PUBLICATION UPDATE BULLETIN

DATE: 03/16/84

Base Documents: 729-0602-A and 729-0935-A

This Publication Update Bulletin (PUB) documents the phase-lock-loop (PLL) adjustment procedure for the 210-8694/8794 board in the 2200LVP/SVP Disk Processing Unit (DPU). The adjustment procedure in this PUB supercedes the one in Section 11.3 of the Model 2200LVP Product Maintenance Manual (729-0602-A). This PUB also serves as an addendum to the 2200SVP Product Maintenance Manual (729-0935-A).

FIGURE 1 WL NO. 210-8694 TEST POINTS AND POTENTIOMETERS

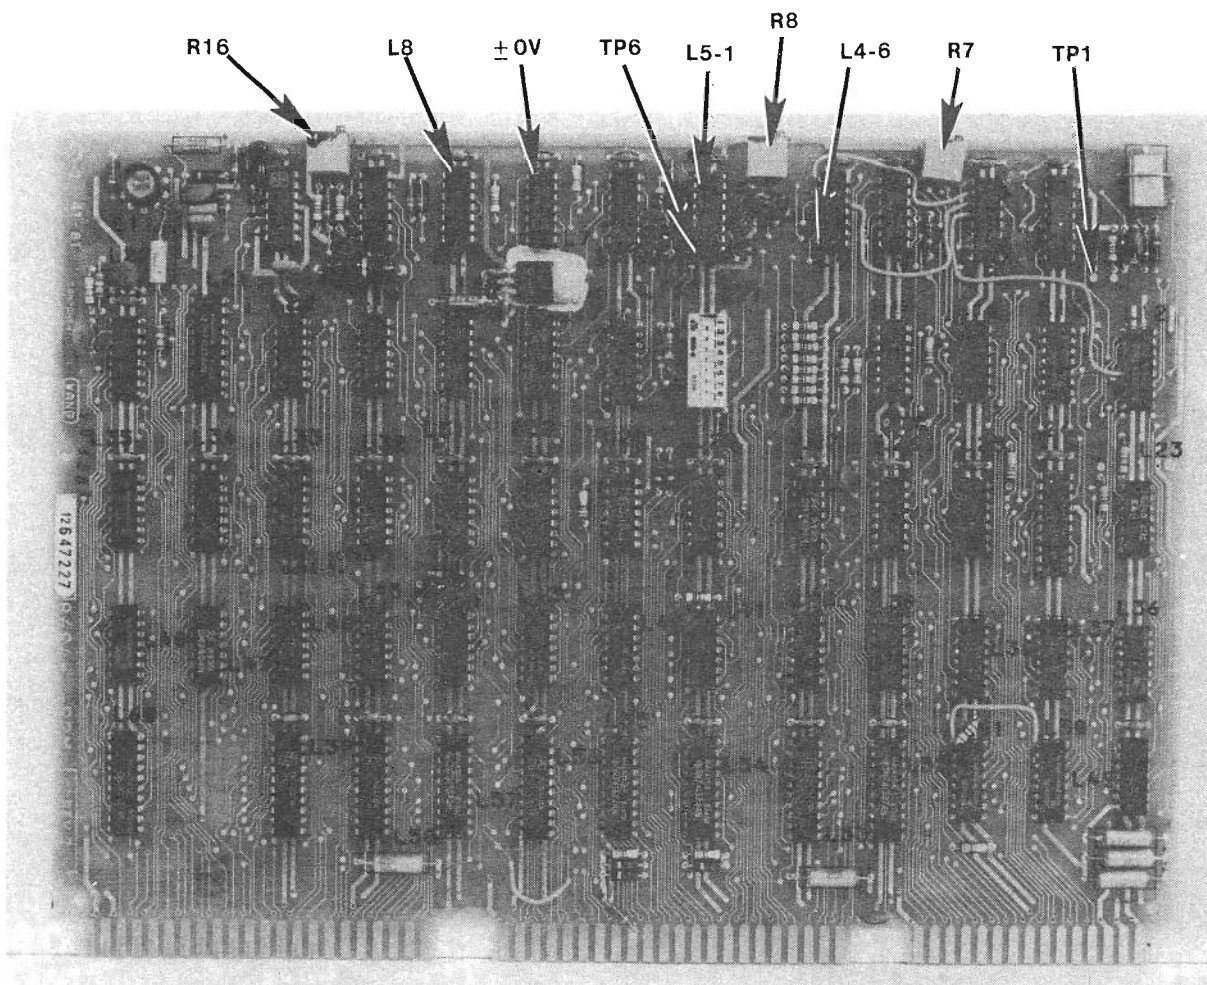
1. Using a jumper wire, connect TP1 (Test Point #1) to +0V (GND).
2. Set the DVM (or oscilloscope) controls to measure +4.00V dc.
3. Connect the DVM (or oscilloscope) ground probe to +0V (GND).
4. Connect the DVM (or oscilloscope) signal probe to L5 pin 1 or 2.
5. Adjust potentiometer R16 for a +4.00V dc indication.
6. Carefully remove the jumper wire from TP1.
7. Connect both oscilloscope probe ground leads to +0V (GND).
8. Connect oscilloscope Channel 1 (or A) probe to L8 pin 11 (phase detector reference clock).
9. Connect oscilloscope Channel 2 (or B) probe to L4 pin 6 (voltage controlled oscillator-VCO-output).

FIGURE 2 PLL CORRECTLY ADJUSTED FOR WINCHESTER DISK DRIVE

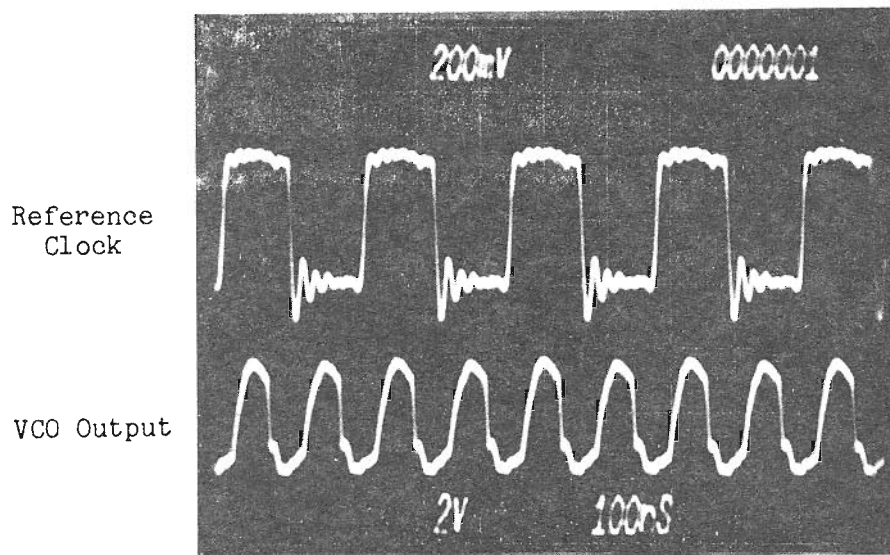
- b. Turn R7 slowly clockwise until the VCO output signal (Channel 2 or Channel B) is stable--not free running.
- c. Continue adjusting R7 clockwise until all the VCO output pulses are centered with respect to the phase detector reference clock pulses (see figure 2). When this condition occurs, the PLL is "locked". When the output pulses are centered, the VCO output pulse period will be approximately 0.115 usec (figure 2).

FIGURE 3 PLL INCORRECTLY ADJUSTED FOR WINCHESTER DISK DRIVE

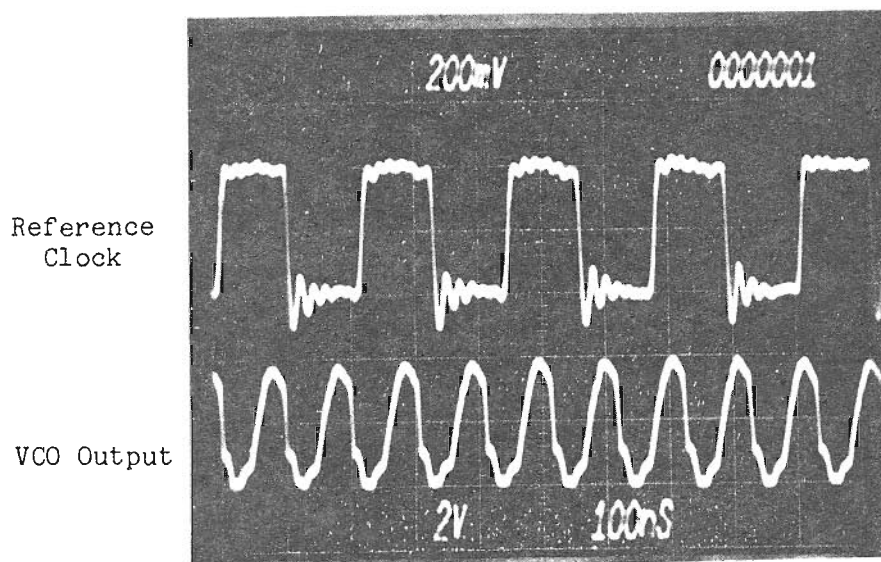
Figure 3 shows an incorrect VCO output signal. Note that the higher frequency of the VCO output in the figure results in an extra pulse (ten instead of nine) in the VCO output.

FIGURE 5 PLL CORRECTLY ADJUSTED FOR DISKETTE DRIVE

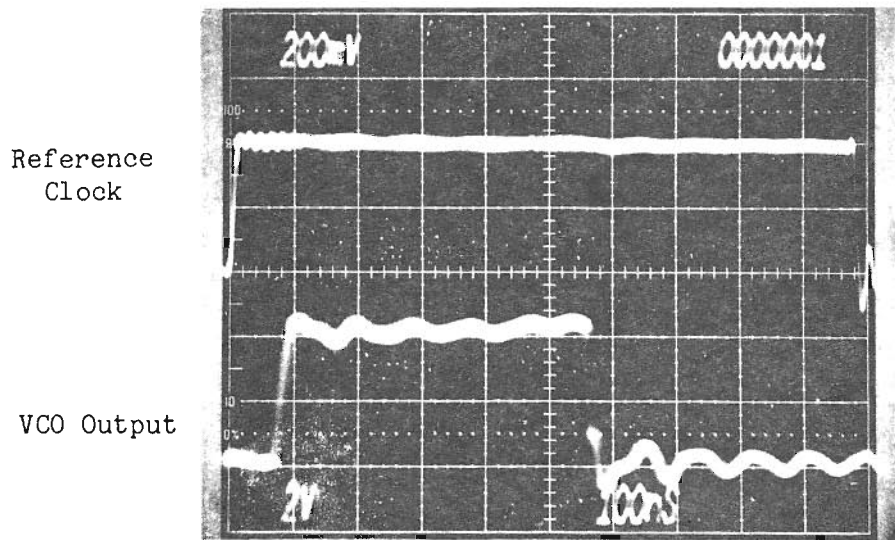
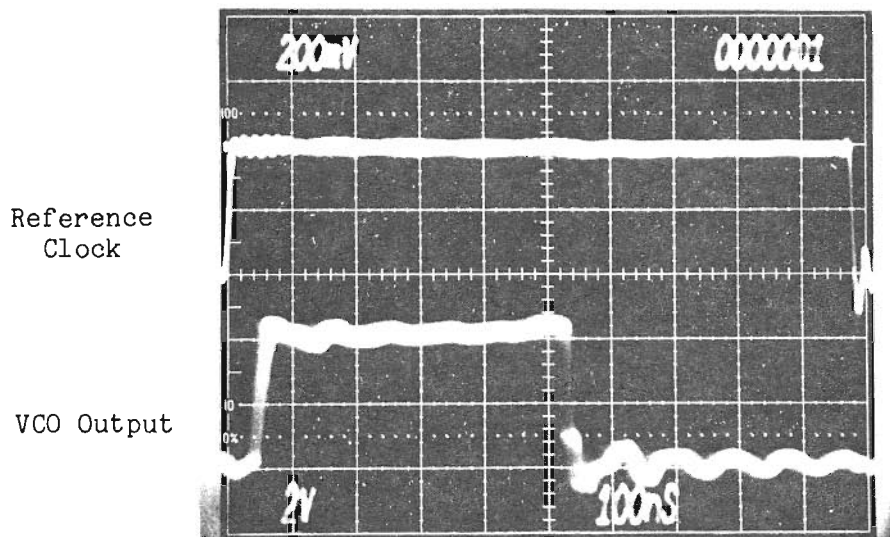
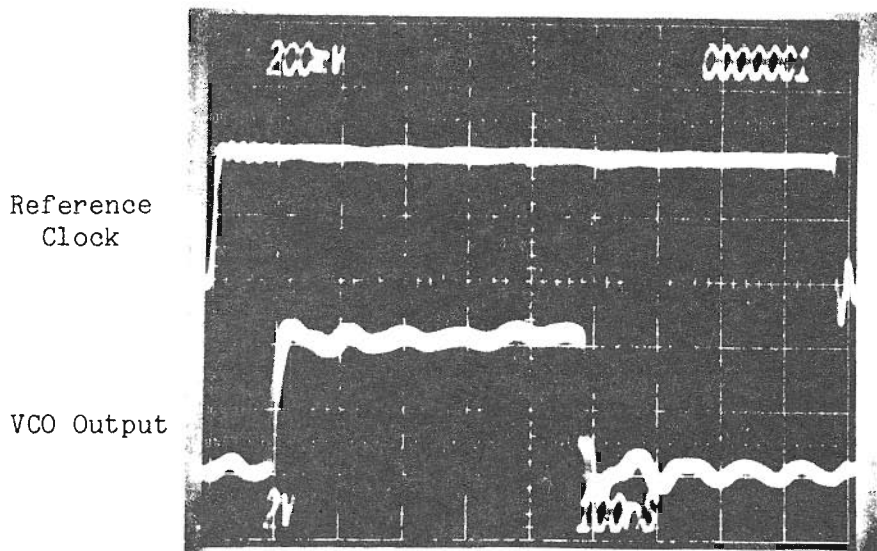
14. Select the diskette drive frequency by connecting a jumper between TP6 and +0V (GND).
15. Slowly adjust potentiometer R8 (diskette drive adjustment) until the leading edge of the VCO output pulse (Channel 2) occurs 0.075 usec after the leading edge of the phase detector reference clock as shown in figure 5. Figures 6 and 7 show incorrect VCO output signals.

**FIGURE 1 WL NO. 210-7291-D (210-7591-A) DAUGHTERBOARD
FOR 2236MXD I/OCONTROLLER**

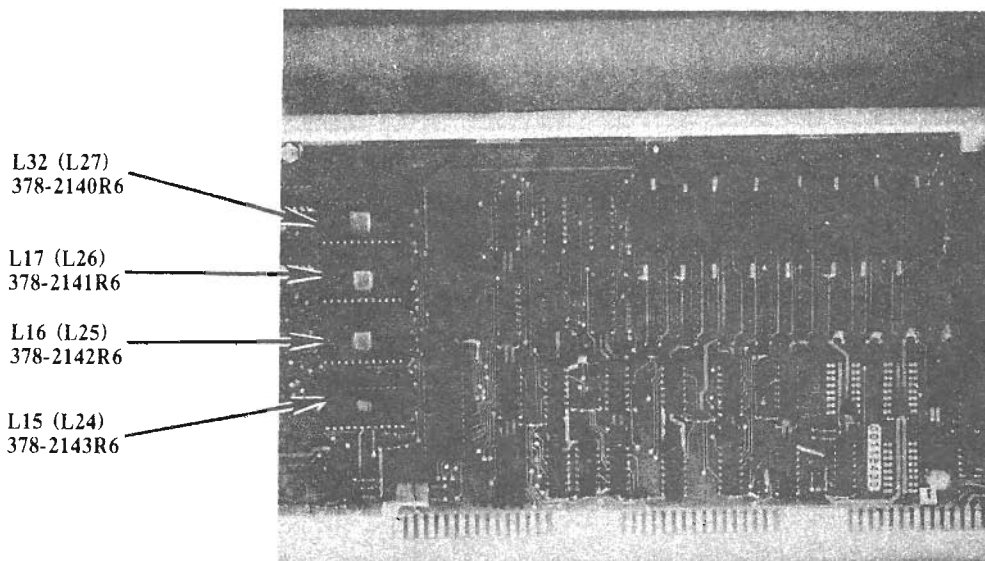
The firmware for the 2236MXD is contained on the WL #210-7291-D (or WL #210-7591-A) board and consists of the following four PROM's (ref: FIGURE 1):

NOTE: PROM revisions should be R6 or above.

**FIGURE 2 WL NO. 210-7290-1A MOTHERBOARD
FOR 2236MXD I/O CONTROLLER**

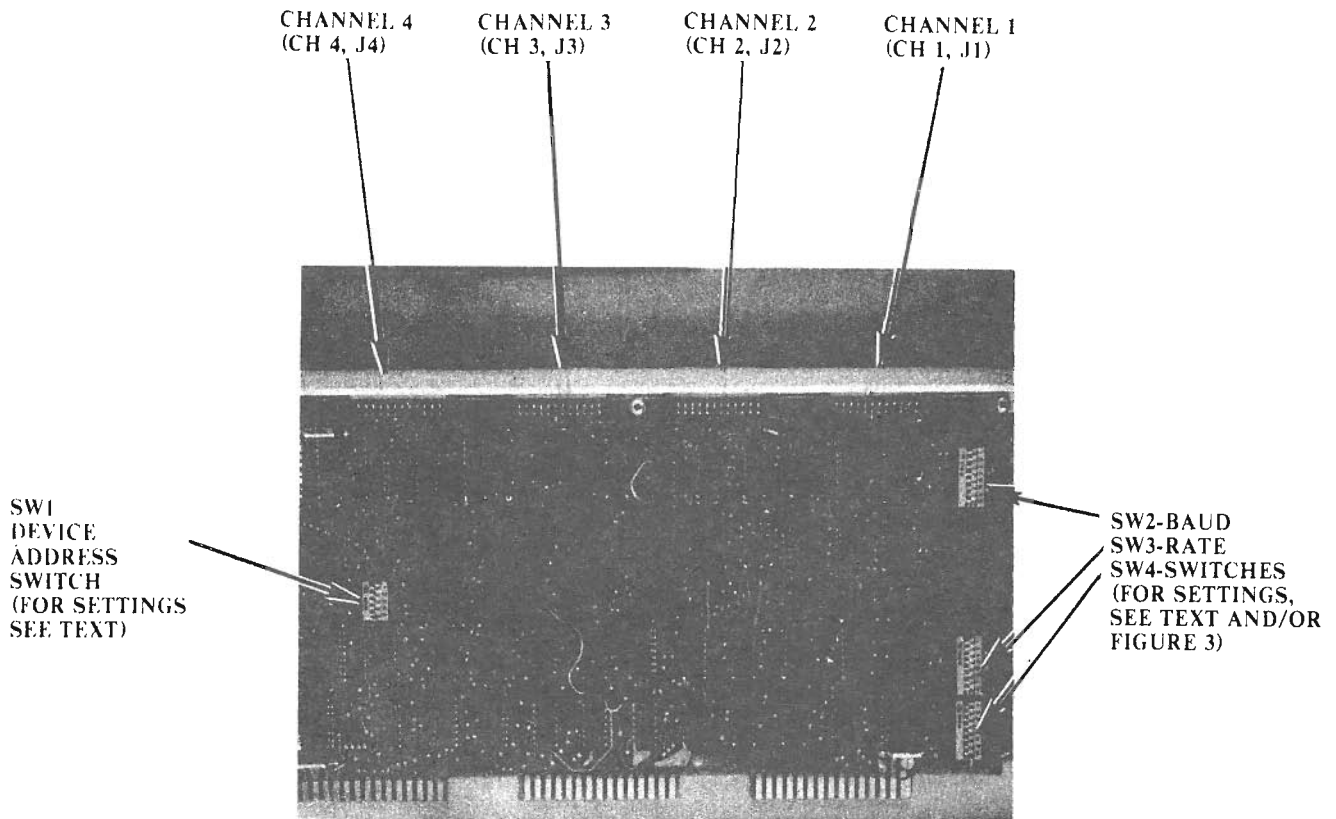
The 2236MXD address is set by means of a five-section switchbank (SW1) located on the WL #210-7290-1A board (ref: FIGURE 2). For systems with a single 2236MXD, set the controller address switches to HEX(00); that is, all five switches in the bank must be OFF. In systems using two 2236MXD controllers, set the address switches of the primary controller (the one with the "system console" connected to channel #1) to HEX(00)--all switches OFF. Set the address switches of the other controller to HEX(40)--switch #1 is ON; all others are OFF. If a third 2236MXD is used, set the address switches of that controller to HEX(80)--switch #2 is ON; all others OFF.

For baud rate selection, there are three, 8-section switchbanks (SW2-SW4) located on the WL #210-7290-1A board (ref: FIGURE 2). These switches comprise four groups of six switches each, with each group corresponding to a channel. The switches in each group are labeled for the specific baud rates (ref: FIGURE 3). Only one switch in any group of six may be ON at any one time. If a terminal is not attached to a channel, the switch settings for that channel are irrelevant. A 2236D/DE terminal and its associated 2236MXD I/O port must have identical baud rate selections. Any local or remote modems must also be set to the same baud rate as the terminal and controller.

FIGURE 1 2200LVP/SVP JUMPER CONFIGURATION (MLC10).

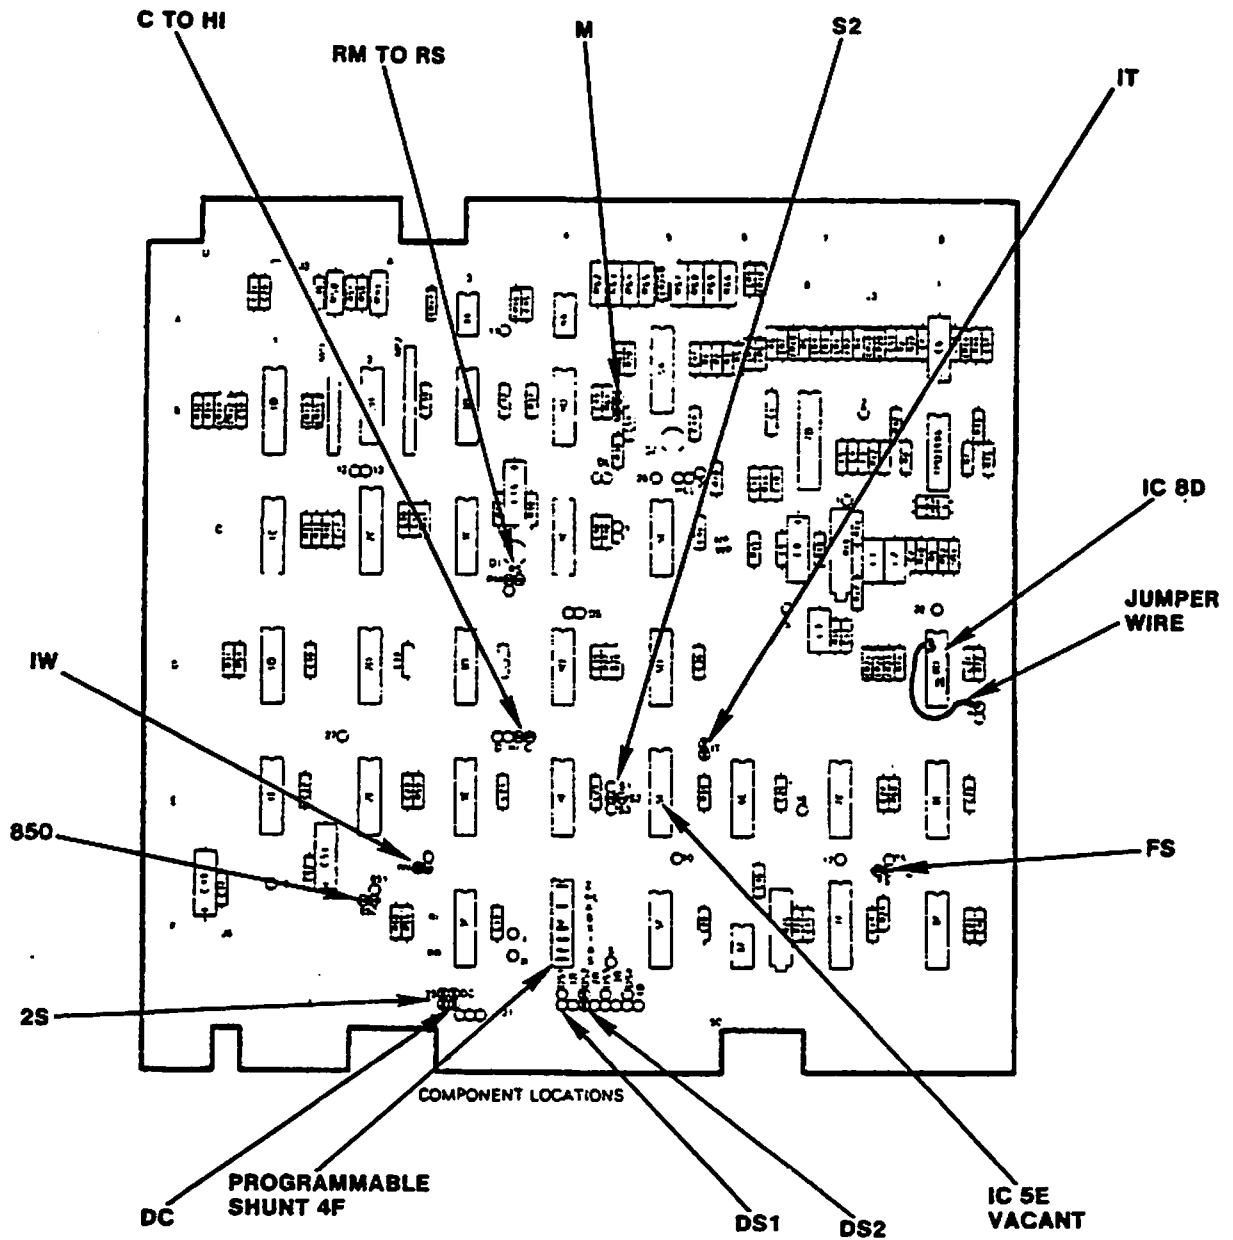
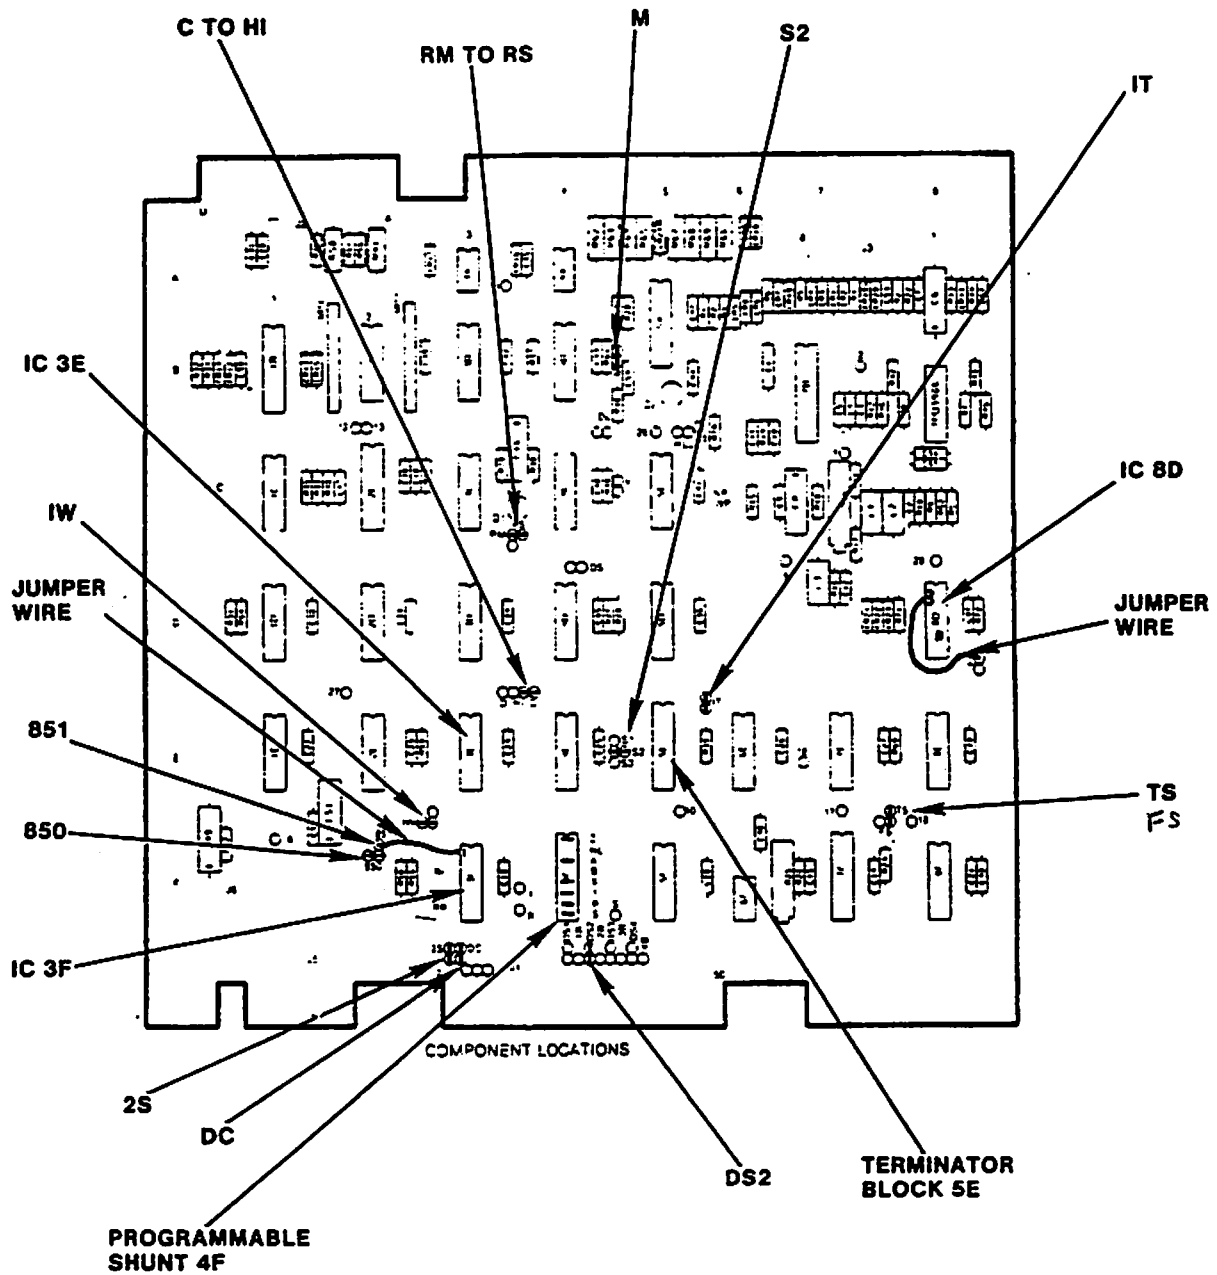
Board MLC 10 must have pins 3 and 11 of IC 8D jumpered together. (Pin 11 is connected to one end of jumper location F. See Figures 1 and 2.) This modification is required for both LVP/SVP and VS-AWS operation. On boards MLC 11 and higher, Shugart has provided a jumper (AF) and a NOR gate (5D) to eliminate the need for this jumper wire.

FIGURE 1
26051 CONTROL BOARD

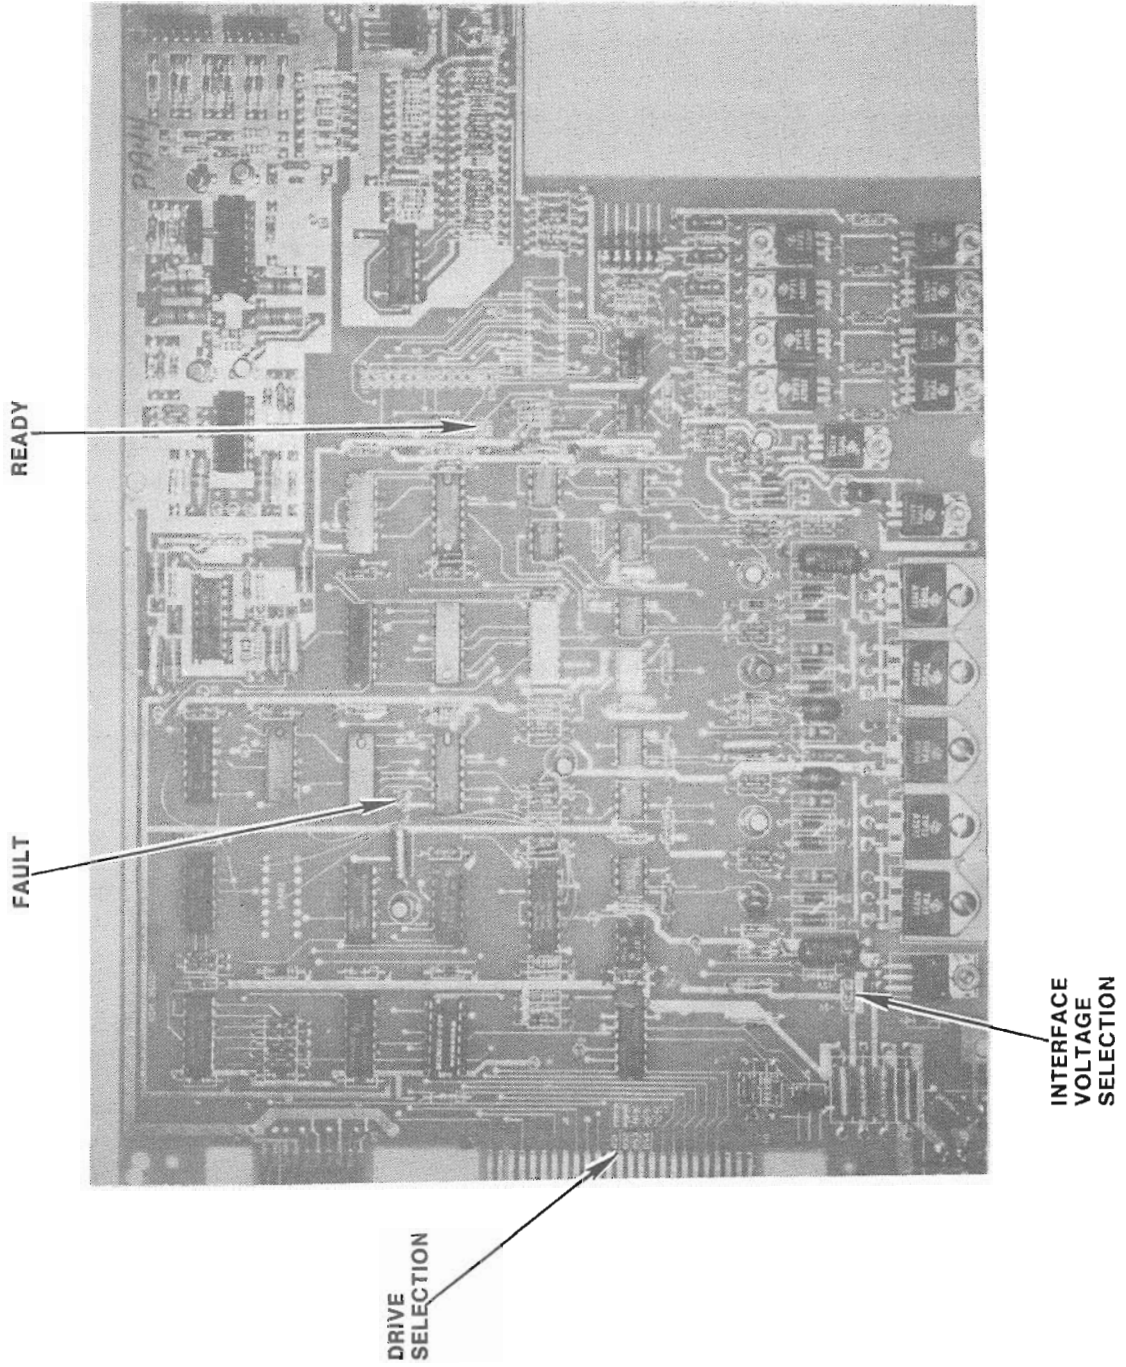
Some SA1000 "Winchester" disk drives are being received at the Lawrence stock room from Shugart Associates with the options jumpers installed incorrectly. These jumpers are on the 26051 Control PCB (WLI #726-1907). It is vital that these options jumpers be verified when a replacement drive is installed in the field. Remove or install the jumpers as described below. Refer to Figure 1 for jumper locations.

1. Fault - When removed, enables the Fault Detection logic. This jumper should be REMOVED.
2. Ready - When removed, enables the Ready signal at the interface. This jumper should be REMOVED.
3. Drive Selection - Selects the disk drive number 1 through 4. INSTALL this jumper for the correct drive number as shown in figure 2.
4. Interface Voltage Selection - Selects the correct interface voltage. INSTALL this jumper for the -5 Volt dc configuration for Wang systems as shown in figure 3.
